Staff Report to the
Municipal Planning Board
March 15, 2022

MPL2021-10072

JUDGE MEADOW APARTMENTS

Landscape Plan

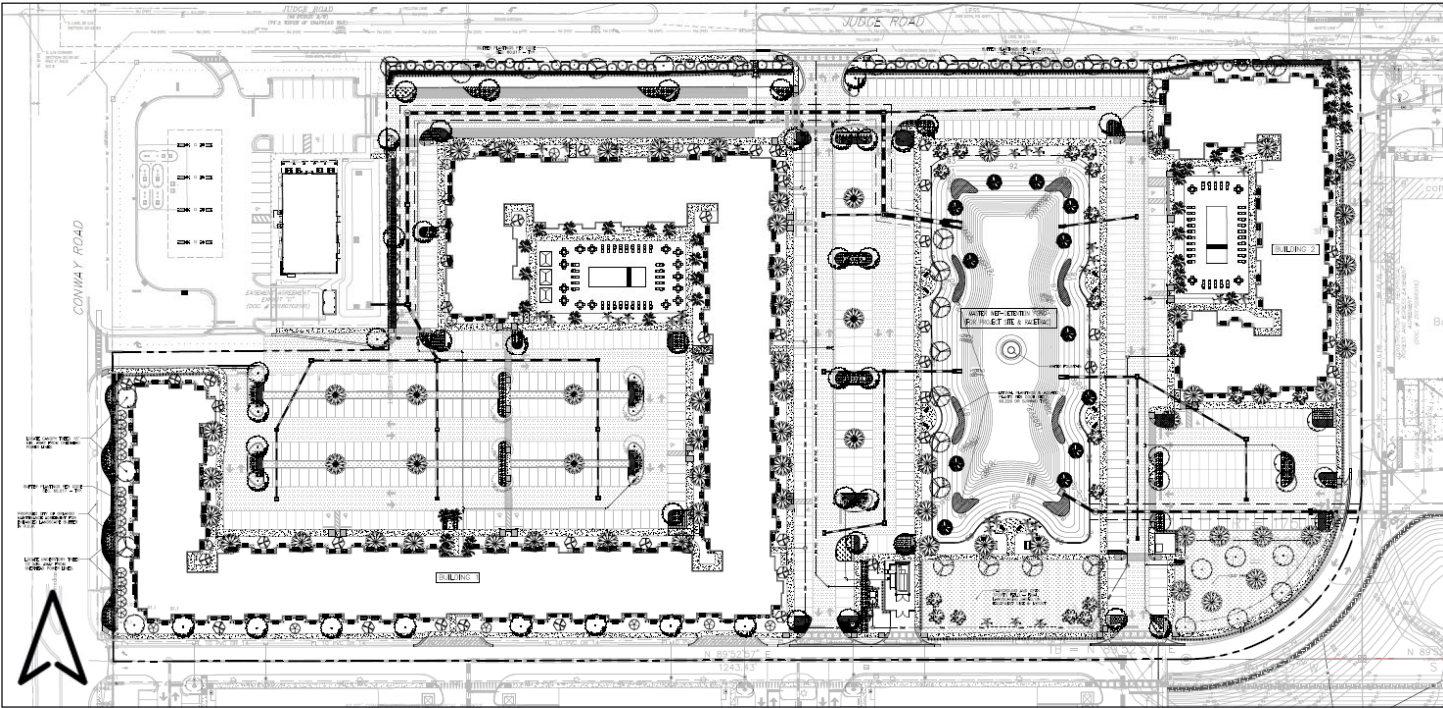
3. The landscape strips along the parking lot wrapped by building #1 must have 6 (six) canopy trees each instead of 3 (three), to provide shade and to reduce heat and glare generated by the paved surface.

4. The Dahool Holly trees proposed between to the east and to the west of the pond adjacent to parking spaces must be replaced with canopy trees.
5. Street trees must be provided along the parkway between the curb and the sidewalk along Judge Rd, in accordance with Chapter 60, Part 2D. Street Trees shall be at least 12 feet in height and 2 inches caliper at time of installation, with a clear trunk height of at least 7 feet.

Proposed Elevations [4-Story Building]

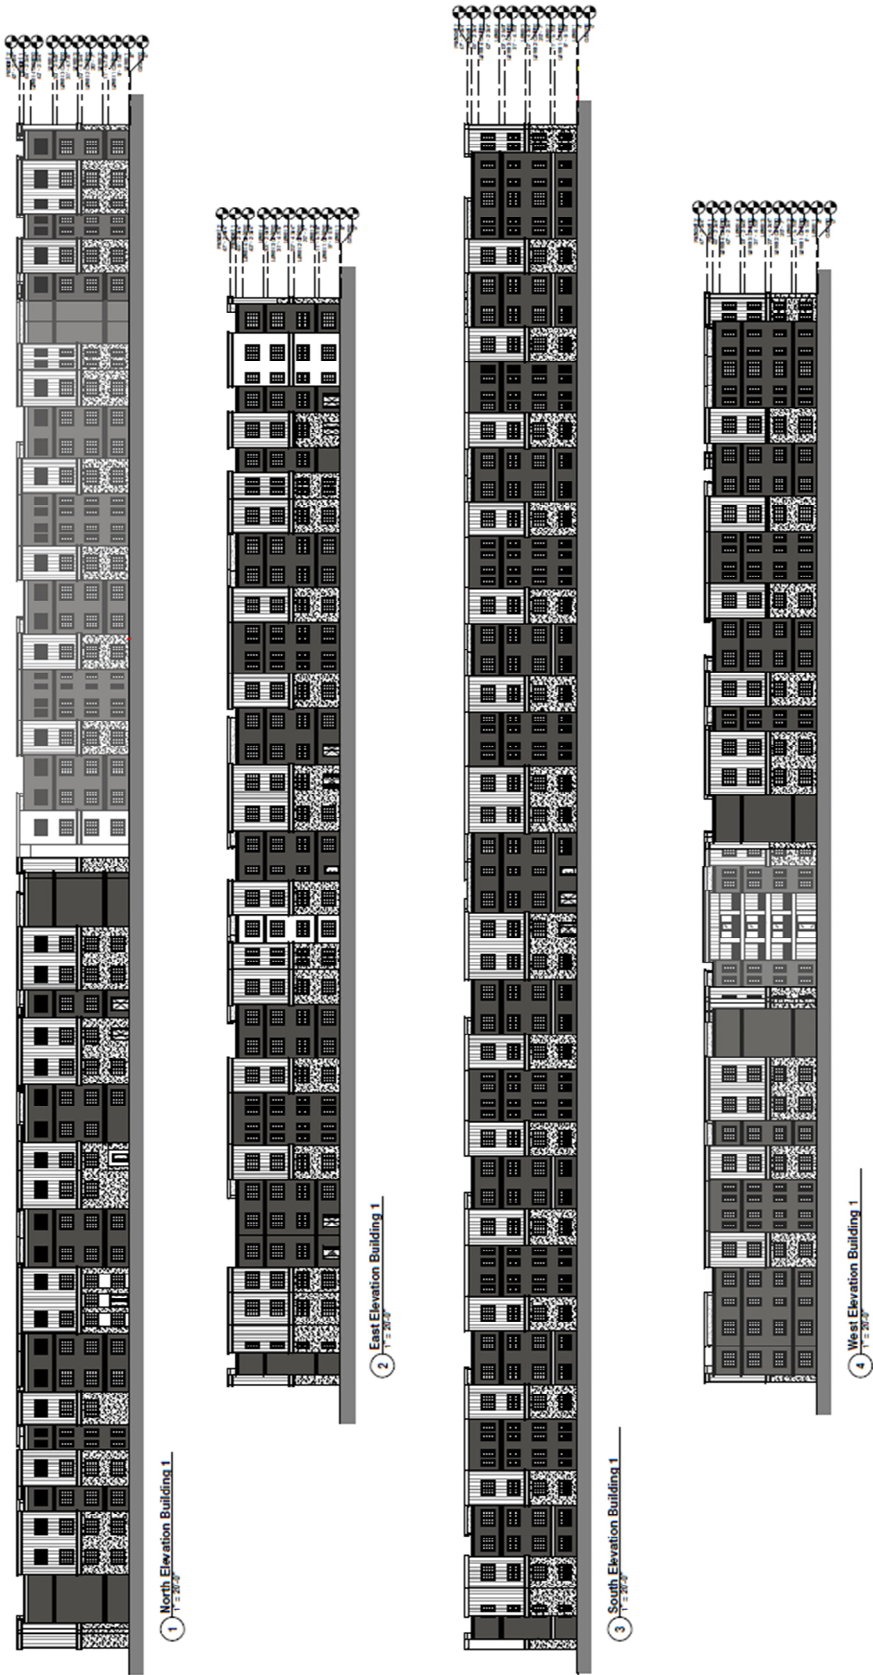
The applicant met multiple times with city staff regarding the architecture of the proposed buildings. Concerns from the proposed architecture are lack of articulation and monotony throughout the buildings. Applicant is working on revised elevations based on staff comments. An Appearance Review and Final Site Plan determination is required before the applicant applies for building permits.

2. Because this development is a PD, superior design is expected, in order to achieve a superior urban form and promote quality development as required in the GMP Urban Design Goals. Additionally, in order to reduce the monolithic appearance, to respect and reflect the pedestrian scale and, to meet GMP goals, building entry modules should be the most defined and articulated modules in the building.

3. All buildings must have a clear and defined base, middle and top.
 - i. Durable materials such as stone, brick or tiles must be utilized on the first story of the building. Stucco is not an acceptable material.

- ii. Additional height and articulation must be added at the building corners, to increase the skyline variations and to better define the mass and extent of the building.

5. All architectural details proposed must be executed so that they add to the overall design of the building. For example, all trim details, including window trims, must be raised from the surface of the building, also all scoring proposed for the building must be deep enough so that the scoring provides shadow lines and reads from the pedestrian environment. Juliette balconies are highly encouraged to break the monotony in lieu of some windows.

8. Staff encourages the applicant to chose a more elaborated color palette, with details and a vibrant accent color that will enhance the design.
